UNITED STATES PATENT AND TRADEMARK OFFICE

APPLICATION NO.	FILING DATE	FIRST NAMED INVENTOR	ATTORNEY DOCKET NO.	CONFIRMATION NO.
10/531,312	09/29/2005	Moshe Cohen Amar	044514-0023	6247

Office Action Summary	Application No.		Applicant(s)	
	10/531,312		AMAR, MOSHE COHEN	
	Examiner		Art Unit	
	Travis M. Reis		2859

DETAILED ACTION

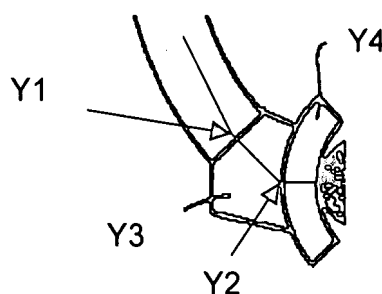
With reference to claim 2, Sauer et al. disclose that the end of the aluminum sheet in contact with the plant has a double bend (Y1, Y2, see below) with convergent side edges, forming a substantially angular (Y3) and rounded end (Y4).
